## INDIANA DEPARTMENT OF TRANSPORTATION

### STANDARDS COMMITTEE MEETING

# FINAL AGENDA

RE: Agenda for the September 18, 2008 Standards Committee Meeting

807-LTFD-09, CONVENTIONAL LIGHT FOUNDATION FOR 33" CONCRETE MEDIAL WALL  
INSTALLATION

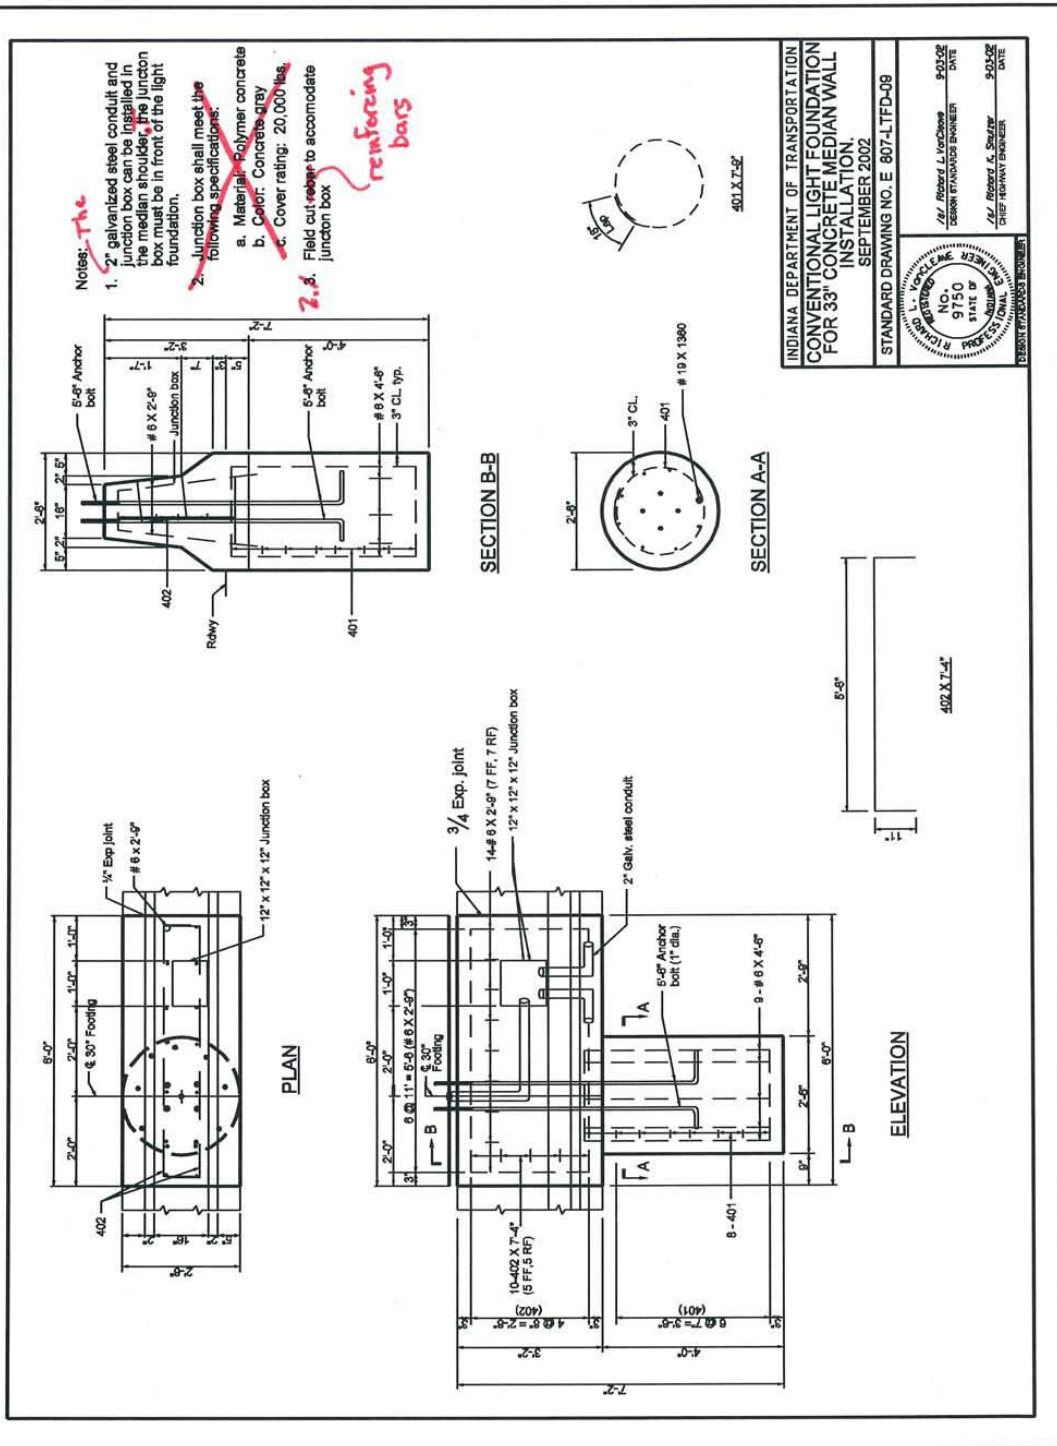
PROBLEM(S) ENCOUNTERED: Removal of material specification note (Note 2) from standard drawing 807-LTFD-09.

PROPOSED SOLUTION: Insert material specification from standard drawing into 920.01(g). Renumber existing 920.01(g) Shop Drawings to 920.01(h) Shop Drawings.

*The junction box shall be polymer concrete, of concrete-gray color, with a cover rating of 20,000 lb (9072 kg).*
